Louisiana Energy Services  
Response to April 29, 2004,  
Request for Additional Information

Louisiana Energy Services (LES)  
Responses to April 29, 2004  
Requests for Additional Information

Figure ER RAI 4-1.1

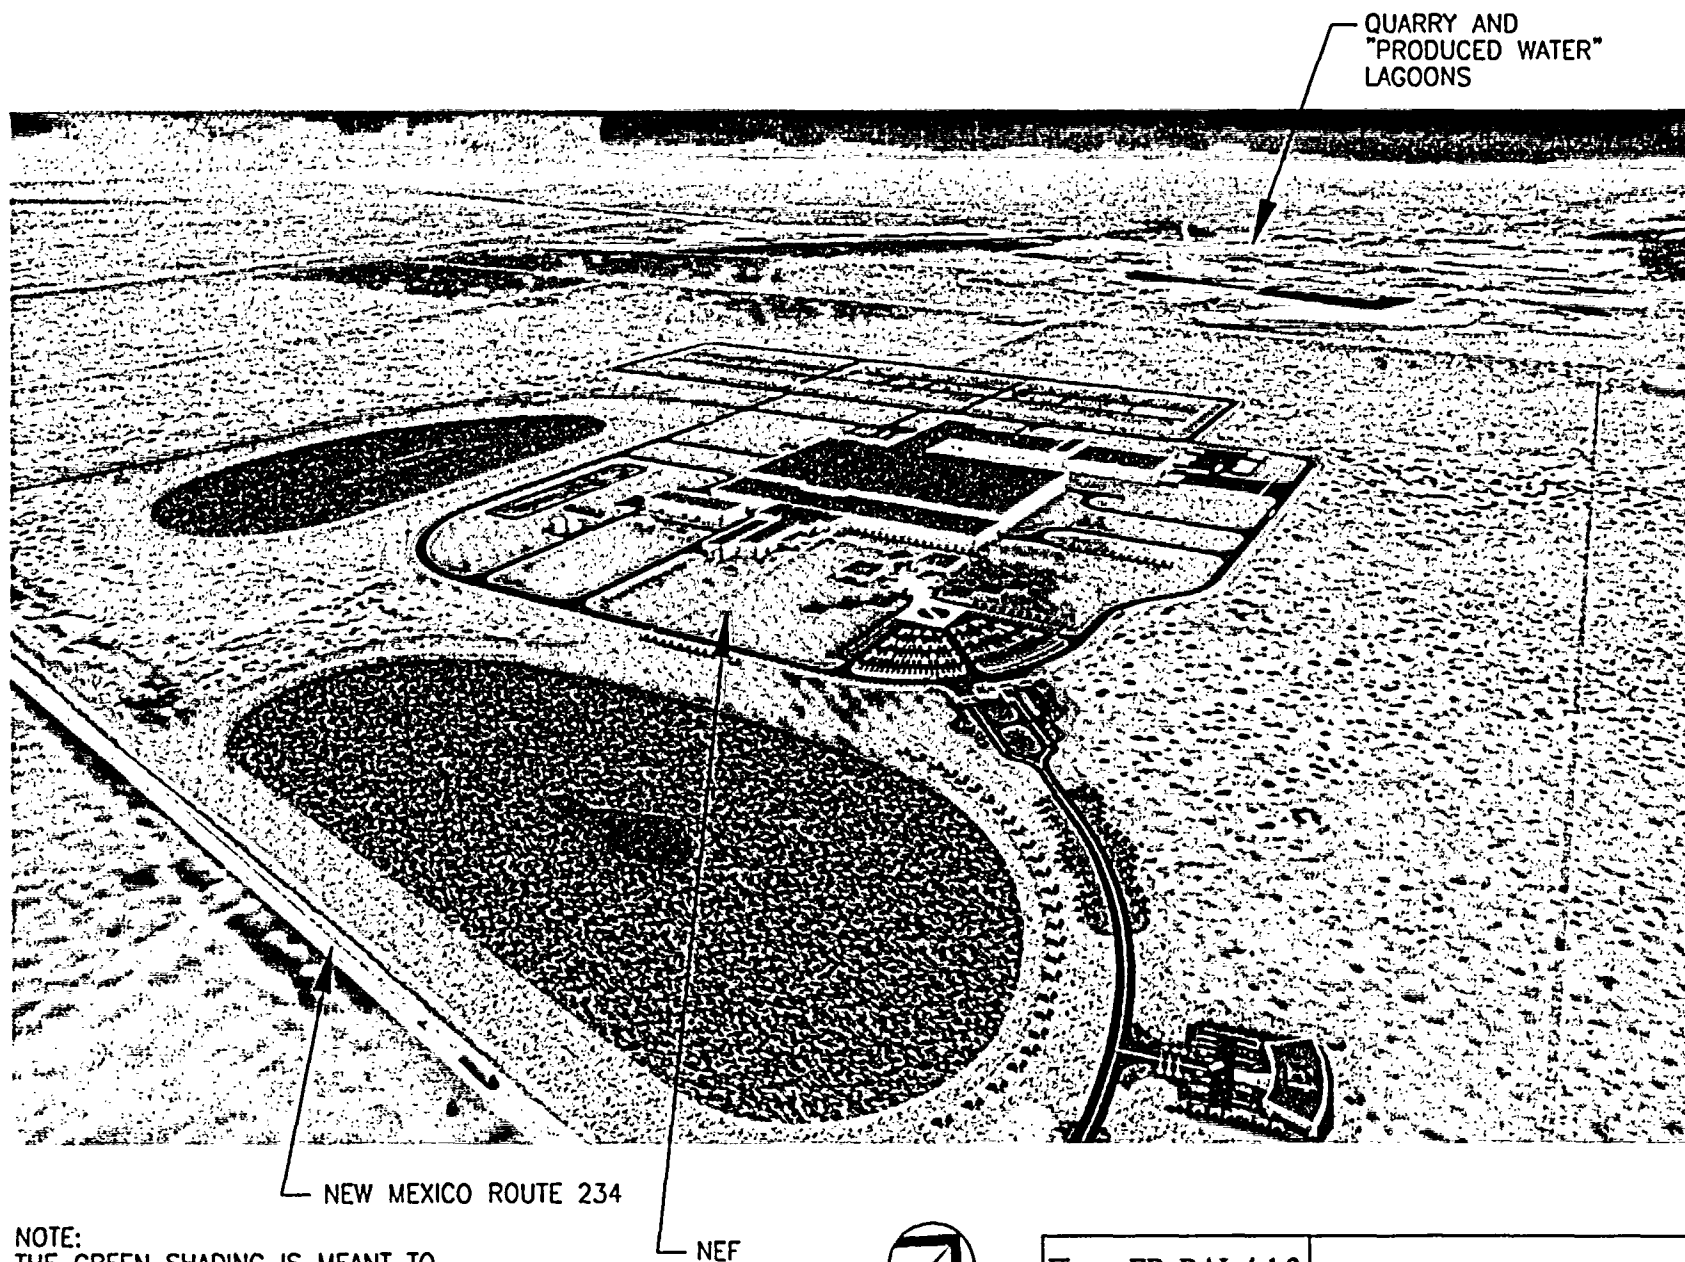
Provide a copy of the artistic rendering showing a view of the proposed NEF and how it would visually impact the site and surrounding area.

Figure ER RAI 4-1.1, "Aerial View," is an artistic aerial view of the NEF and surrounding area. Figure ER RAI 4-1.2, "View to the Northwest," Figure ER RAI 4-1.3, "View to the East," Figure ER RAI 4-1.4, "View to the South," and Figure ER RAI 4-1.5, "View to the West," in Attachment 3 to this submittal, provide artistic views of the NEF site and vicinity, looking to the northwest, east, south and west, respectively. The quarry and "produced water" lagoons to the north, the existing Waste Control Specialists (WCS) waste facility to the east, the county landfill to the southeast and New Mexico Route 234 to the south are shown in relation to the NEF site. Land to the west, occupied by a petroleum contaminated soil treatment facility, is undeveloped. Viewing the surrounding area from the NEF site, and looking northward, the quarry and "produced water" lagoons are at a higher elevation. To the east, several low-rise buildings associated with the WCS waste facility are apparent at a distance. Earthen mounds are apparent to the southeast, across New Mexico Route 234. No structures are visible on the adjacent property to the west.
